CALPINE CORPORATION

**RE: Response to Request for Additional Information
Deer Park Energy Center LLC
Deer Park, Harris County, Texas**

On behalf of Deer Park Energy Center LLC, Calpine Corporation is hereby submitting this response to the October 28, 2011 request for additional information for the pending Deer Park Energy Center application for a Prevention of Significant Deterioration (PSD) air quality permit for greenhouse gas (GHG) emissions. The questions asked in the letter are duplicated below followed by a response:

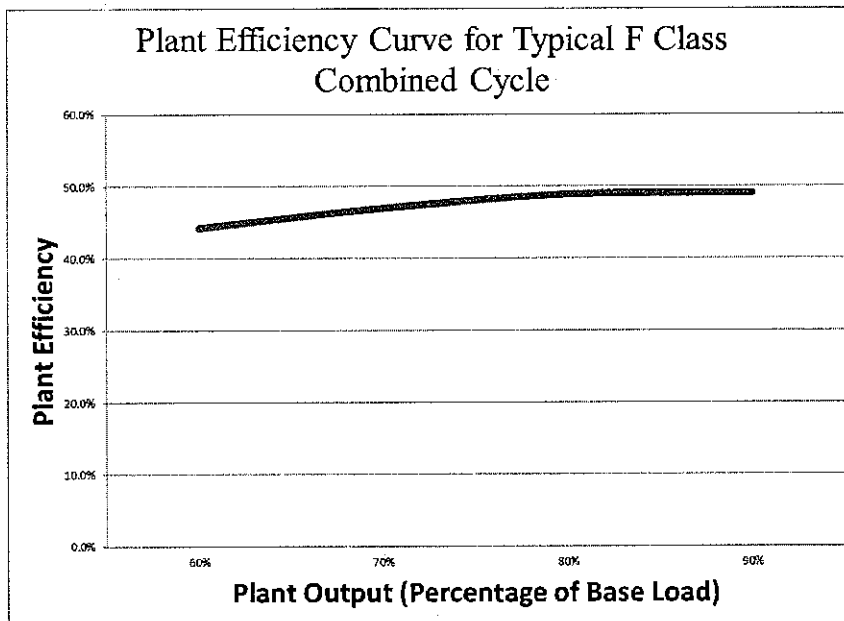
4. *Please provide a basis and documentation to support the base heat rate compliance margins listed on page 40 of the permit application.*

To establish an enforceable BACT condition that can be achieved over the life of the facility, the permit limit must also account for anticipated degradation of the equipment over time between regular maintenance cycles. A 48,000-operating-hour degradation curve provided by Siemens reflects anticipated recoverable and non-recoverable degradation in heat rate between major maintenance overhauls of approximately 5%. The degradation curves describe the amount of "recoverable" and "non-recoverable" degradation. The former includes degradation that can be recovered through compressor water washing, filter changes, instrumentation calibration and auxiliary equipment maintenance. The latter includes degradation that cannot be restored upon a maintenance overhaul.

The manufacturer's degradation curves only account for anticipated degradation within the first 48,000 hours of the gas turbine's useful life; they do not reflect any potential increase in this rate which might be expected after the first major overhaul and/or as the equipment approaches the end of its useful life. Further, the projected 5% degradation rate represents the average, and not the maximum or guaranteed, rate of degradation for the gas turbines. Therefore, Deer Park Energy Center proposes that, for purposes of deriving an enforceable BACT limitation on the proposed facility's heat rate, gas turbine degradation may reasonably be estimated at 6% of the facility's heat rate.
